**General Electric Company
Hudson River Project**

**REVIEW OF THE HUDSON RIVER PCBs
REASSESSMENT RI/FS PHASE 2 REPORT
VOLUME 2B -
PRELIMINARY MODEL CALIBRATION REPORT**

**Presented to the
U.S. Environmental Protection Agency, Region II**

February 5, 1997

SOLIDS MASS BALANCE FOR 1994 FLOOD (30 March 1994 - 28 April 1994 - 30 Days)

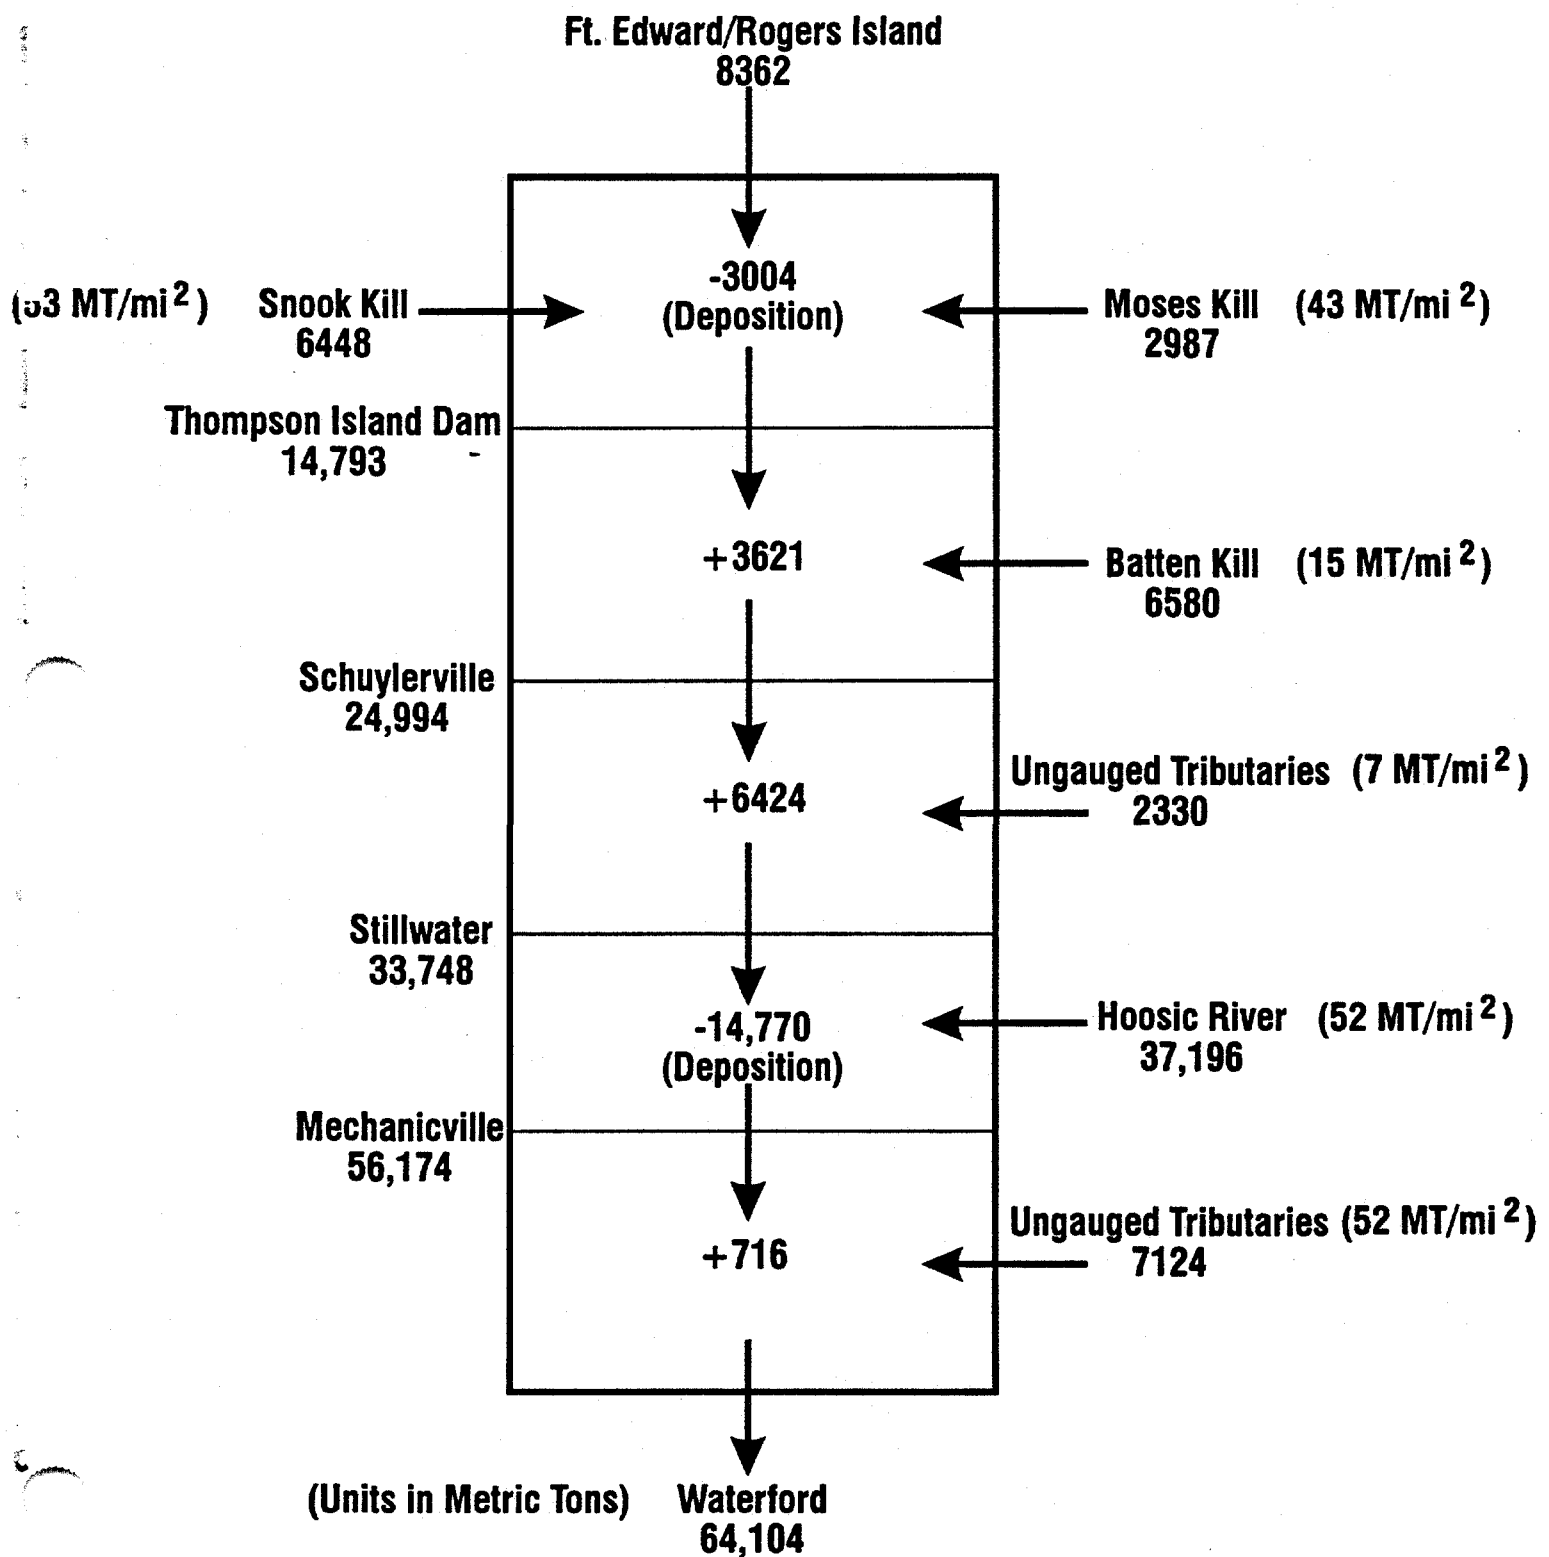
- **Solids mass balance is inaccurate**
 - **loadings from TIP tributaries are underestimated**
 - **deposition and resuspension rates, particularly at low flow, are too high**
 - **sedimentation is not integrated into the model as the net of deposition and resuspension, violating the principle of mass balance**

HUDTOX SOLIDS BALANCES

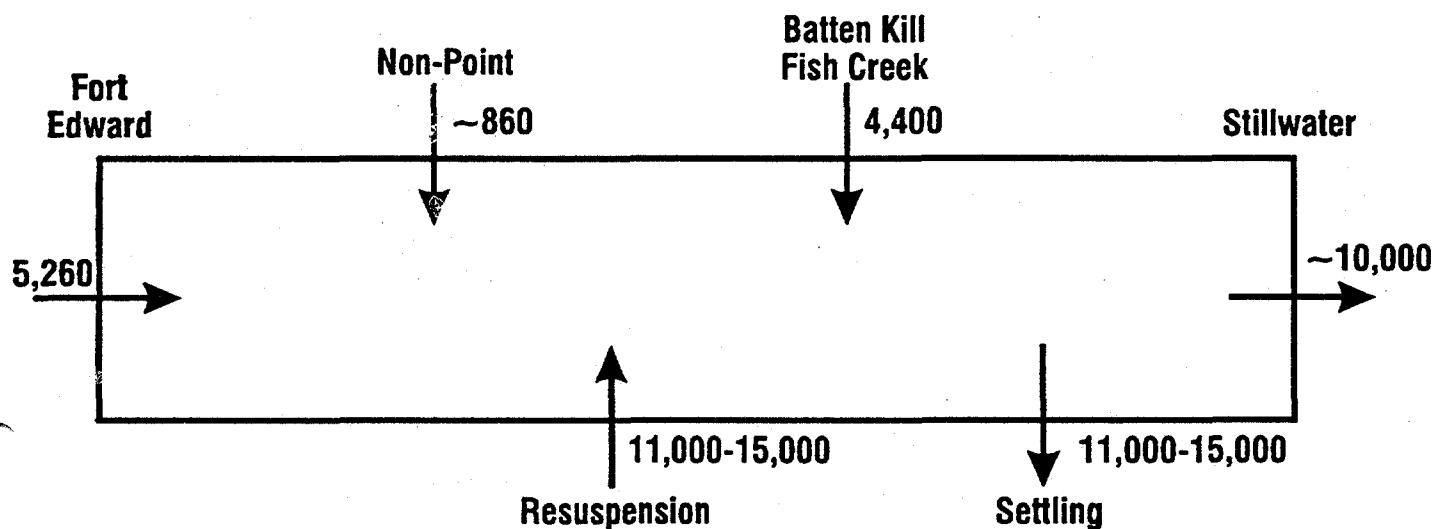
**SOLIDS IN = SOLIDS OUT. Therefore, No Calibration
Check on Settling & Resuspension**

Figure 4-32
HUDTOX Predicted Total PCB Concentrations vs. Observed Values (ng/L)
Phase 2 Transect Data

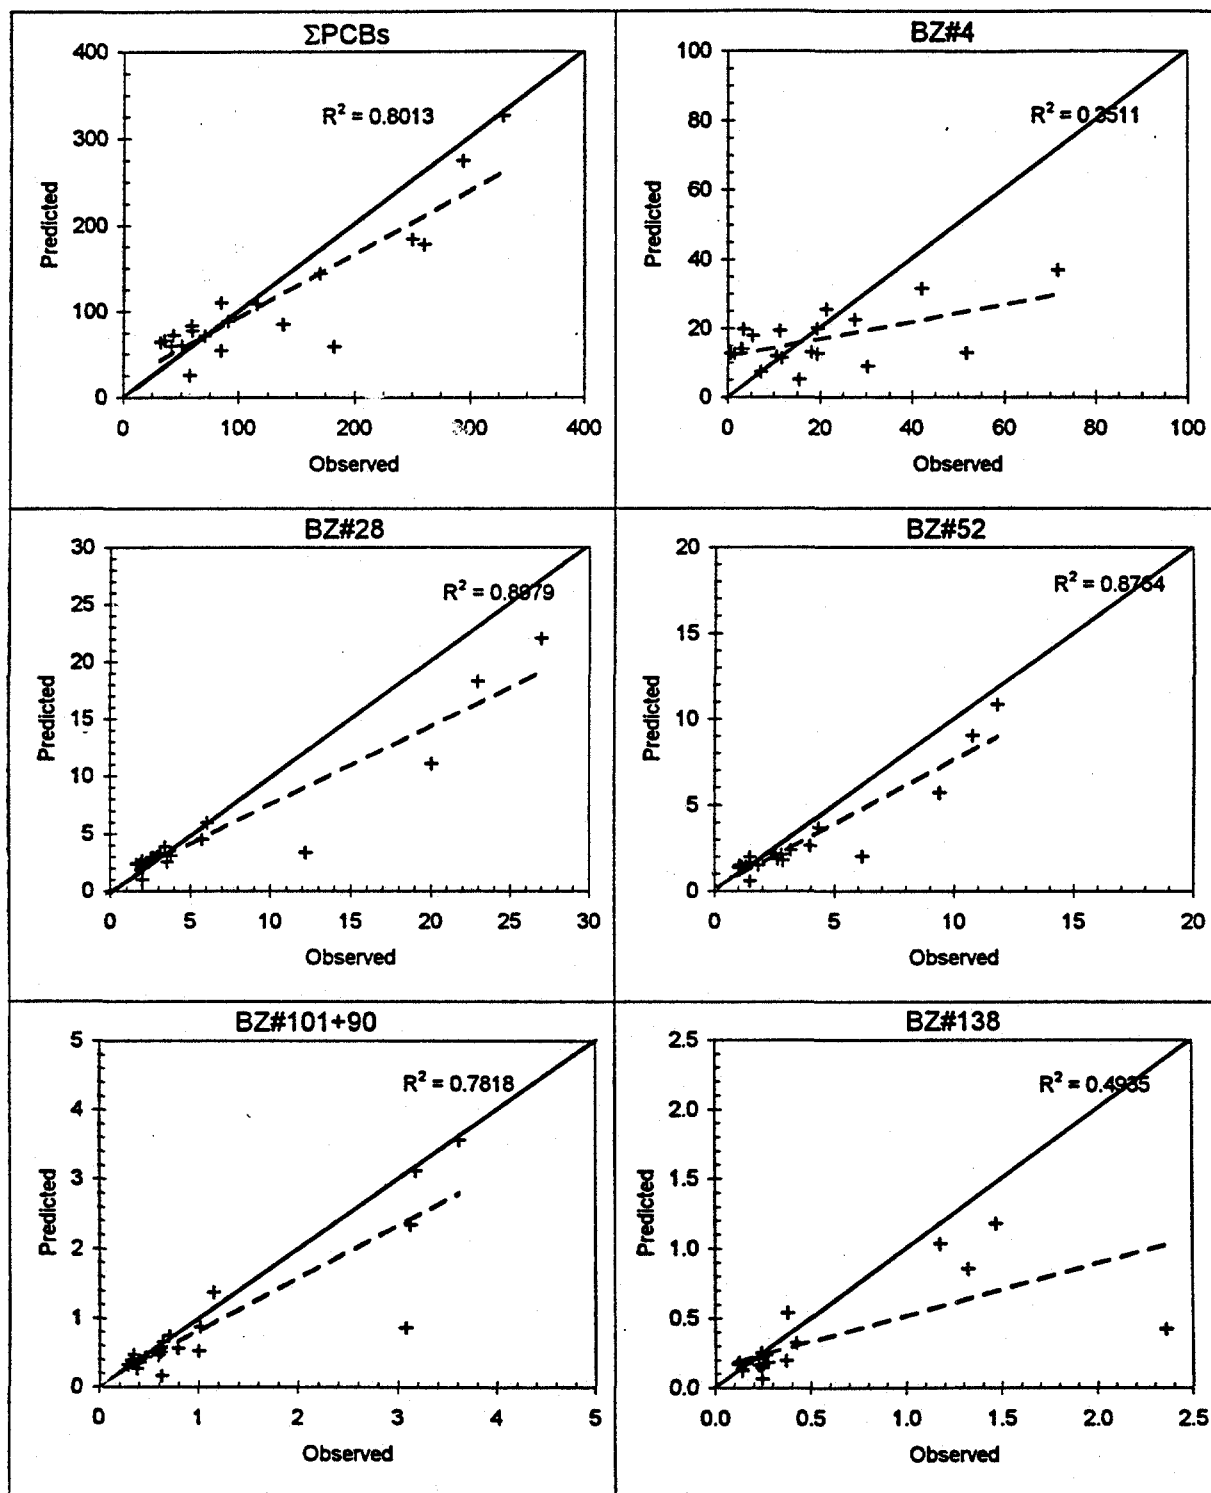
**PCB MODEL OVERESTIMATES WATER COLUMN PCB
Concentrations at Low Flows, Indicating Settling &
Resuspension are Too High**

Figure 4-37
TSS Mass Balance for HUDTOX Calibration Period (1/1/93-9/30/93)
Spring Runoff Event Period (3/26/93 - 5/10/93)

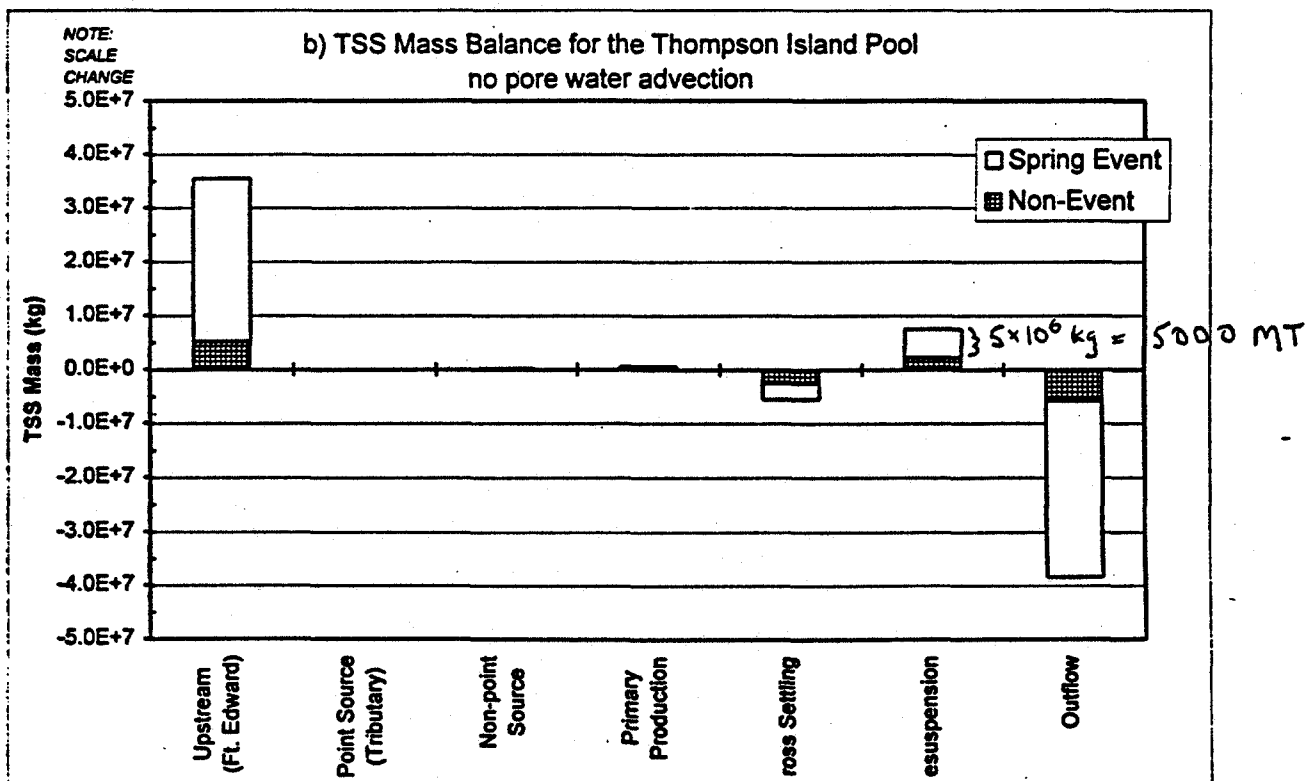
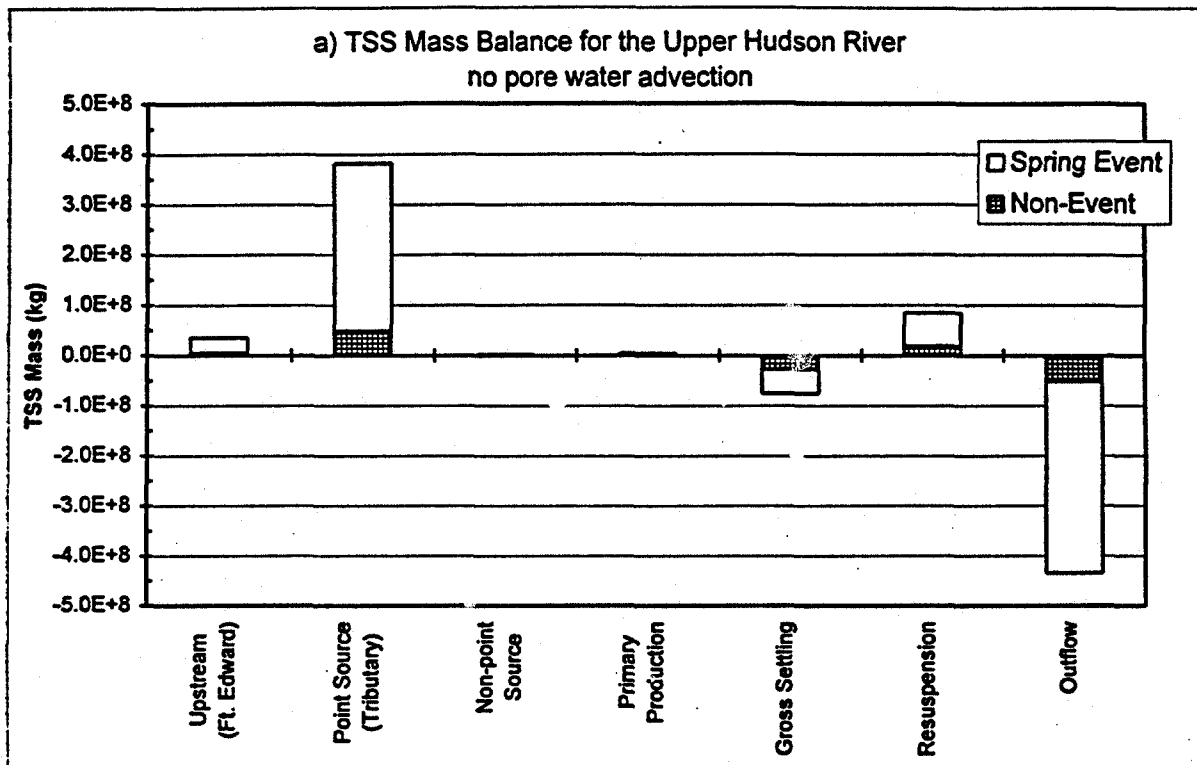
- High flow resuspension is not inhibited by bed armoring (i.e., resuspension continues as long as velocity exceeds some threshold value)
 - inconsistent with the approach used in the 100 year flood model
 - may exaggerate the transfer of PCBs from the bed to the water column
 - resuspension rate is determined solely by calibration (i.e., no mechanistic basis)

Figure 4-14
Total PCB Calibration - Σ PCBs for January - September 1993

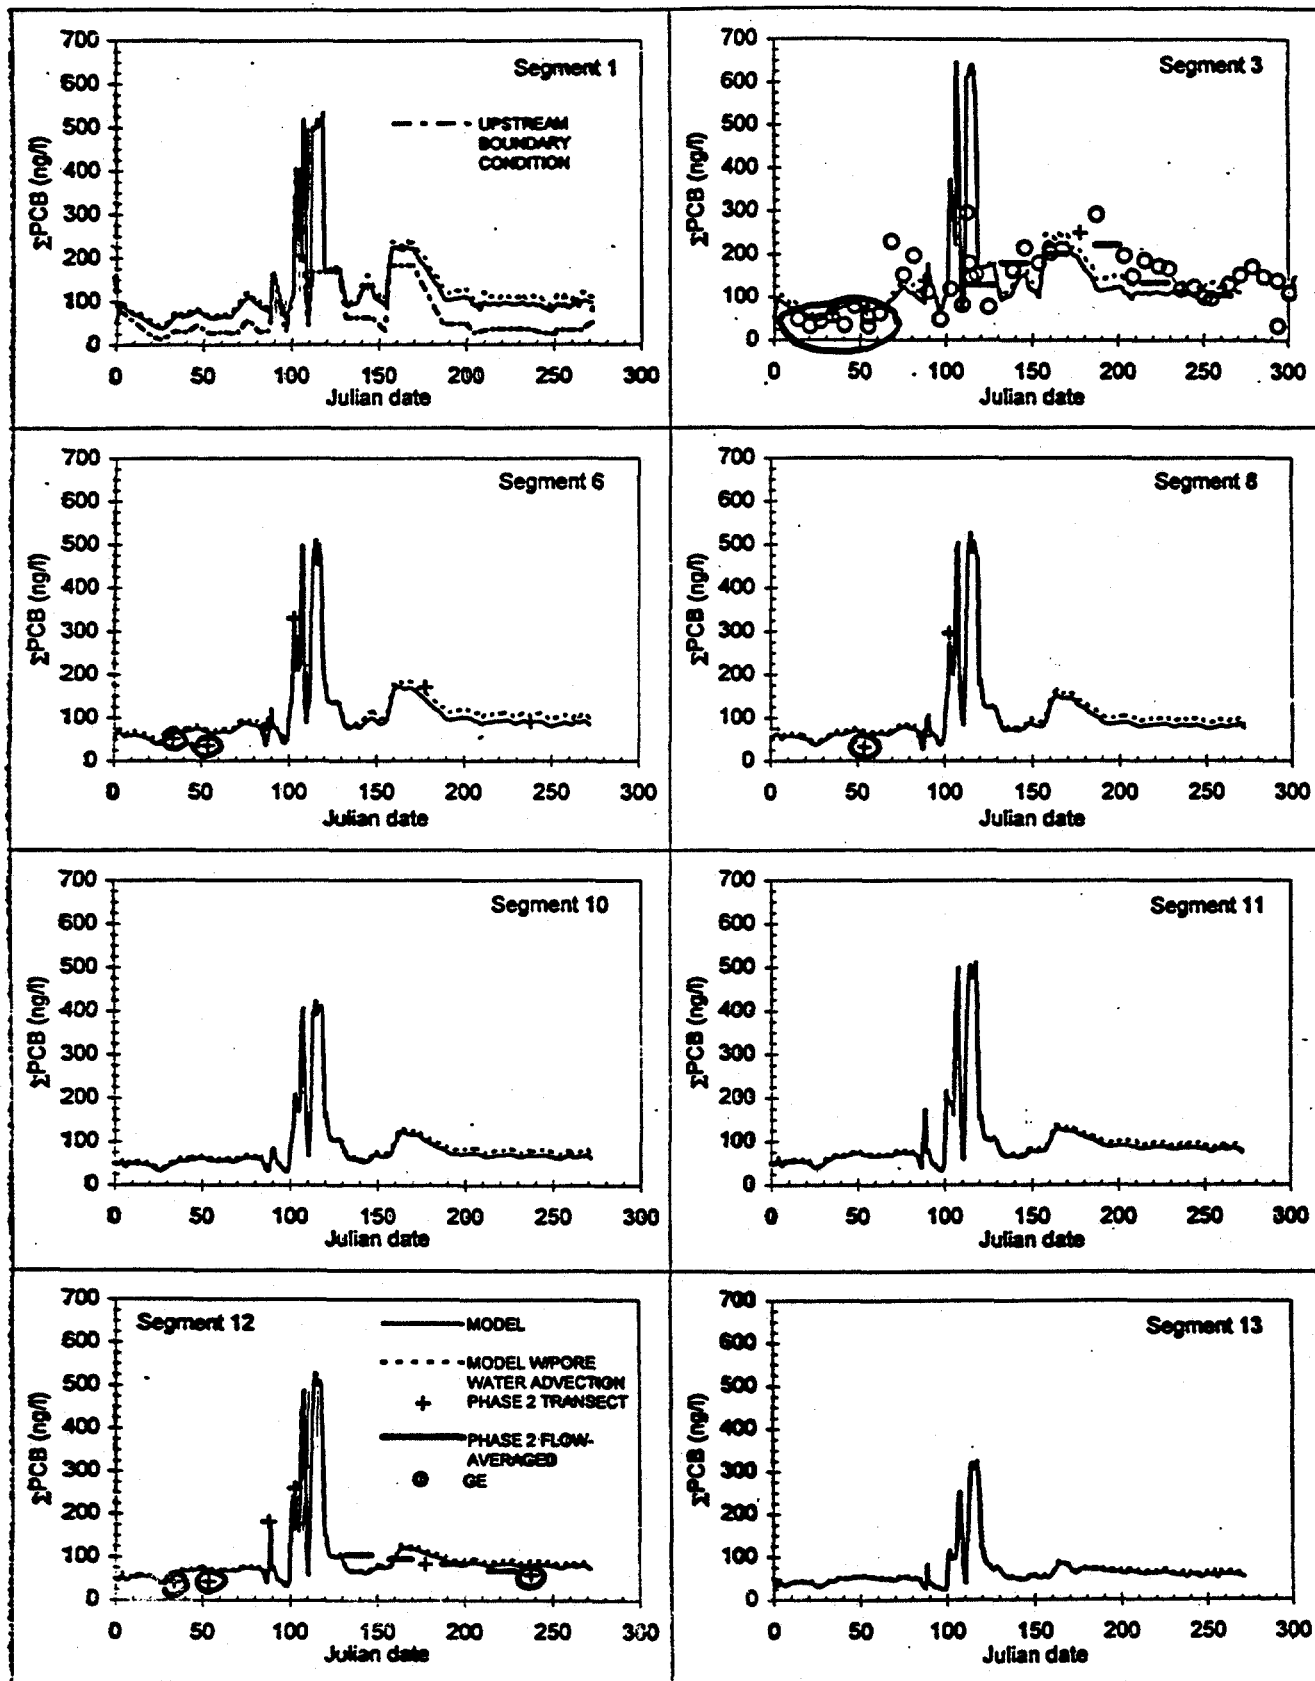
- Model is unable to achieve a PCB mass balance across TIP, despite resorting to hypothesized mechanisms for which there is no factual demonstration
 - groundwater flux of buried PCBs was applied
 - model over predicts PCBs in winter and under predicts PCBs in summer
